Design Review Report – Item 1

Local government:	City of Stirling	
Item no.:	Item 1 – DA23/0802 – 92 Princess Road, Balga – Development Assessment Panel – Form 1 – Child Care Premise	
Chairperson:	Emma Williamson	
Panel members:	Anthony Duckworth Peter Damen Jackson Liew	
Local government officers:	Dean Williams Karina Bowater Simone Palmer Kelly Douglas	Acting Coordinator Planning Senior Planning Officer DRP Support Officer Client Liaison Officer
Observers		
Date:	2 November 2023	Time: 2pm
Venue:	City of Stirling – Challenger Room

Design quality evaluation Item 1 – DA23/0802 – 92 Princess Road, Balga – Development Assessment Panel – Form 1 - Child Care Premises DRP Meeting – Thursday 2 November 2023 and 3 August 2023	
	<i>Design Principle satisfied</i>
	<i>Design Principle pending further attention</i>
	<i>Design Principle not satisfied</i>
Principle 1 Context and character	<i>Good design responds to and enhances the distinctive characteristics of a local area, contributing to a sense of place.</i>
	<p>1a. The Panel discussed the importance of the proximity of the proposal to the neighbourhood centre, the opportunity to link with this and the impactful nature of the corner site.<

PROJECT	BALGA				DRAWING	PLANTING PLAN				ISSUE	ISSUED FOR FEEDBACK			
CLIENT	-				DRAWING NO	SCALE	SHEET	REVISION	DRAWN	DATE				
					L-02	1:150	A1	2	NK	12/10/23

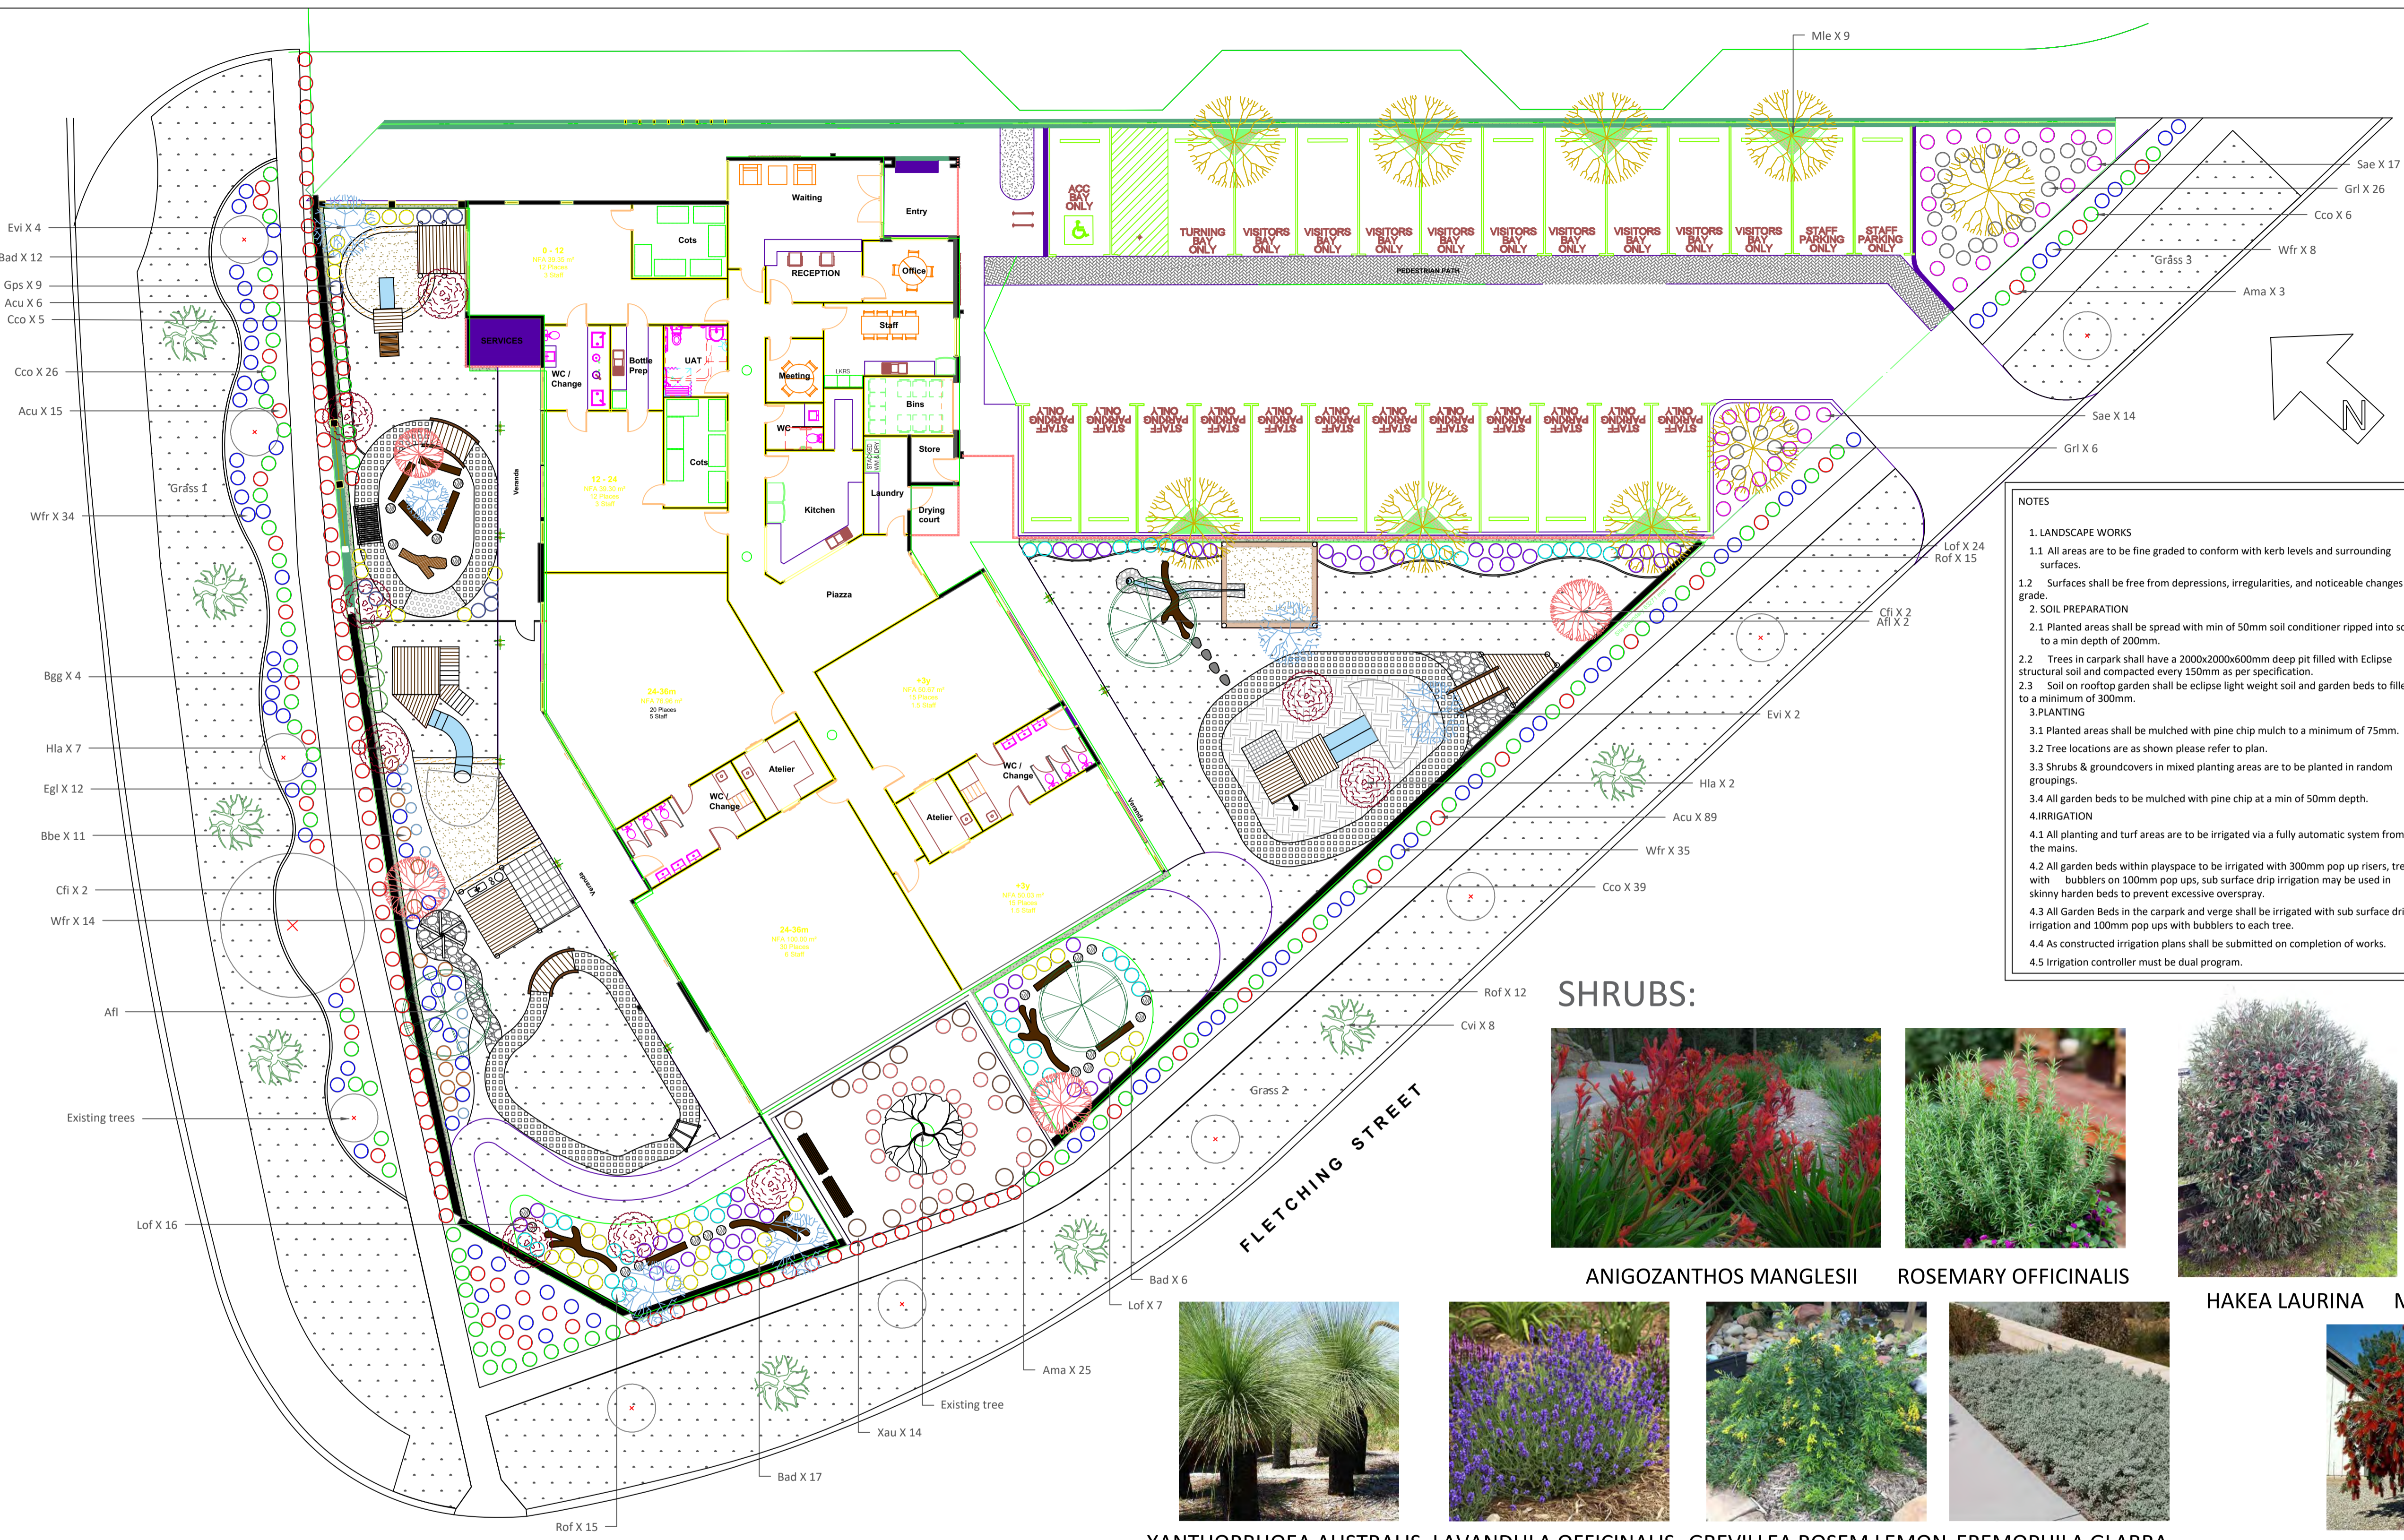
Principle 2 Landscape quality	<i>Good design recognises that together landscape and buildings operate as an integrated and sustainable system, within a broader ecological context.</i>
	<p>2a. The Panel support the retention of the large Jarrah tree on site. The Panel recognize the challenge that this creates due to the changes in levels across the site. The Panel understand the approach by the Applicant to fence around the tree, making this area publicly accessible and expressed concern in relation to the potential for this to become neglected. The Panel request further clarification in relation to the maintenance, amenity and safety of this area.</p> <p>2b. The Panel commented on the opportunity and need to include additional trees on the site. Increasing the extent of trees in the carpark is one obvious area where the landscape can be used to enhance the proposal and reduce the urban heat island effect. Additionally, trees could be incorporated into the play spaces, creating meaningful shade for children.</p> <p>2c. The Panel commented on the need for an integrated landscape and architecture response to shade across the scheme noting that the “tin roof” nominated over the sandpit was not considered a good quality outcome. Elements within the landscape spaces, particularly shade structures require architectural resolution.</p> <p>2d. Comment was made by the Panel the northern connection of the pedestrian access path to the footpath on Princess Road requires resolution and integration as the current landscape proposal prevents this connection.</p>

<p>2a. The Panel do not support the removal of the large Jarrah tree on site and request an arborist report to establish the viability of the tree. The suburb of Balga has a critically low tree canopy (less than 6%) and every effort needs to be made to prevent further diminution.</p> <p>2b. Comment was made by the Panel clarity around the calculations and usability of the outdoor spaces is required, noting that some of the west-facing areas appear too small to be practical. It is important to ensure outdoor spaces can be safely used by the occupants and the design of these areas should be integrated into the plans.</p> <p>2c. The Panel commented on the</p>	<p>2a. Jarrah tree retained with significant area remaining undisturbed for root ball, which an arborist is to advise on this.</p> <p>2b. Outdoor spaces have been designed, refer to Landscape Design, with approx. 40m2 area additional area provided.</p> <p>2c. Additional trees included.</p> <p>2d. Slopes areas have been incorporated to create dynamic play spaces.</p> <p>2e. Recycled asphalt paving is proposed. Soak wells will permeate stormwater equally effectively as permeable paving.</p> <p>2f. A pedestrian accessway has been provided along the northern façade with additional</p>	<p>2a. The Panel support the retention of the large Jarrah tree on site. The Panel recognize the challenge that this creates due to the changes in levels across the site. The Panel understand the approach by the Applicant to fence around the tree, making this area publicly accessible and expressed concern in relation to the potential for this to become neglected. The Panel request further clarification in relation to the maintenance, amenity and safety of this area.</p> <p>2b. The Panel commented on the opportunity and need to include additional trees on the site. Increasing the extent of trees in</p>

<p>opportunity and need to include additional trees on site. Increasing the extent of trees in the carpark is one obvious area for this.</p> <p>2e. The Panel commented on the opportunity to further develop the design of the retaining wall within the play spaces to make this an interesting and dynamic element.</p> <p>2f. It was suggested by the Panel to consider permeable paving in the carpark area.</p> <p>2j. Comment was made by the Panel the external pathway on the northern edge of the building is narrow and it's purpose is unclear. The Panel queried the need for fencing here and whether the opportunity exists to landscape this area to the street.</p>	<p>entrance door included.</p>	<p>the carpark is one obvious area where the landscape can be used to enhance the proposal and reduce the urban heat island effect. Additionally, trees could be incorporated into the play spaces, creating meaningful shade for children.</p> <p>2c. The Panel commented on the need for an integrated landscape and architecture response to shade across the scheme noting that the "tin roof" nominated over the sandpit was not considered a good quality outcome. Elements within the landscape spaces, particularly shade structures require architectural resolution.</p>
